DECISION

on one-time inspection of elevator actuator joint with elevator bracket for the lack of bushes.

RRJ0000-OR-470-8879/C

1. ELEVATOR ACTUATOR JOINT DISASSEMBLING PROCEDURE.

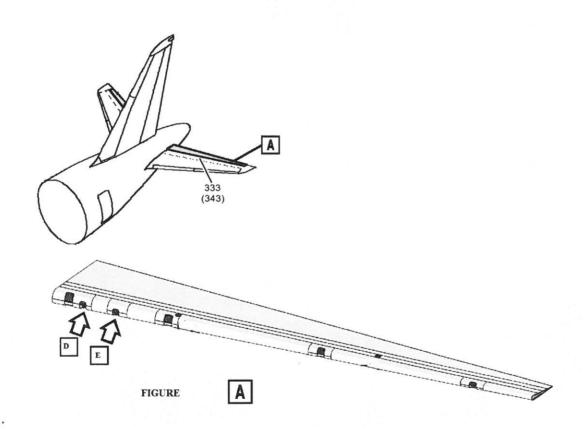
- 1. Remove dust, contaminants, oil leak signs and moisture found on actuator mounting bracket with cleaning rags steeped in HEΦPAC-C2-80/120;
 - 2. Remove and dispose the cotter pin (9);
- 3. Unscrew the nut (8) and remove the washer (7). Safe keep the nut and washer for the following assembly procedure;
 - 4. Unscrew the bolt (3) and remove the washer (4). Dispose the washer;
 - 5. Dismount the bolt (5);
- 6. Take the actuator eyelet (10) away from the eyelet of actuator mounting bracket;
- 7. Remove the bushes (6) and (11). Safe keep the bushes for the following assembly procedure.

2.1 INTERNAL ACTUATOR (fig. D).

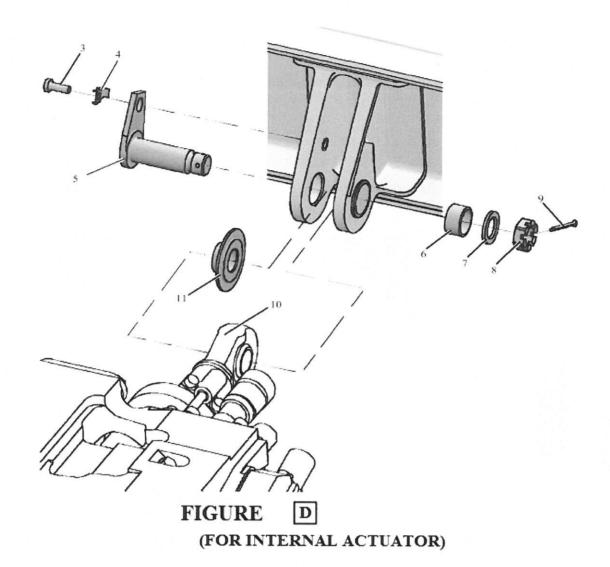
- 1. Apply the thin layer of AЛКМ-1 compound with the brush on the bush (11) mounting surfaces;
 - 2. Install the bush (11);
- 3. Apply the thin layer of grease "Эра (ВНИИ НП-286M)" with the brush onto functional surfaces and threads of bolts 3, 5 and the bush (6);
- 4. Place elevator actuator eyelet (10) inline with actuator mounting bracket eyelets;
 - 5. Install the bolt (5) onto the bush (6);
 - 6. Install the washer (7) and fit the nut (8);
 - 7. Install the bolt (3) and a new washer (4);
 - 8. Lock the bolt (3) with the washer (4);
 - 9. Tight the nut (8) with the torque (17 ± 3) N·m [(12.5 ± 2.2) lbf·ft];

FIGURE E (FOR EXTERNAL ACTUATOR)

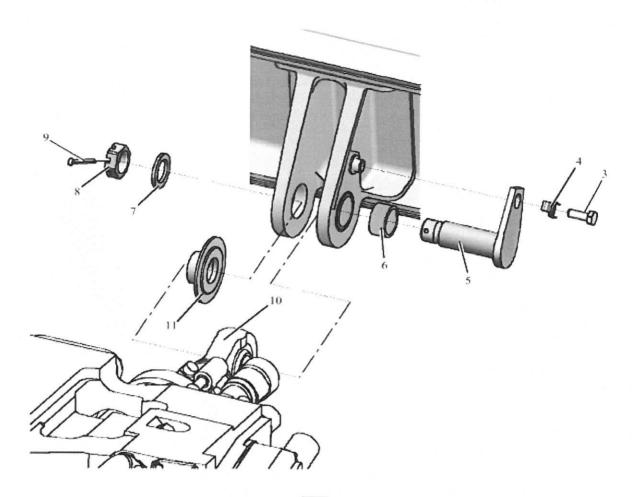
- 1. Apply the thin layer of AЛКМ-1 compound with the brush on the bush (11) mounting surfaces;
 - 2. Install the bush (11);
- 3. Apply the thin layer of grease "Эра (ВНИИ НП-286M)" with the brush onto functional surfaces and threads of bolts 3, 5 and the bush (6);
- 4. Place elevator actuator eyelet (10) inline with actuator mounting bracket eyelets;
 - 5. Install the bush (6) on the bolt (5);
 - 6. Install the bolt (5) with installed bush (6) in to eyelets;
 - 7. Install the washer (7) and fit the nut (8);
 - 8. install the bolt (3) and a new washer (4);
 - 9. Lock the bolt (3) with the washer (4);
 - 10. Tight the nut (8) with the torque (17 ± 3) N·m [(12.5 ± 2.2) lbf·ft];
 - 11. Lock the nut (8) with the new cotter pin (9).
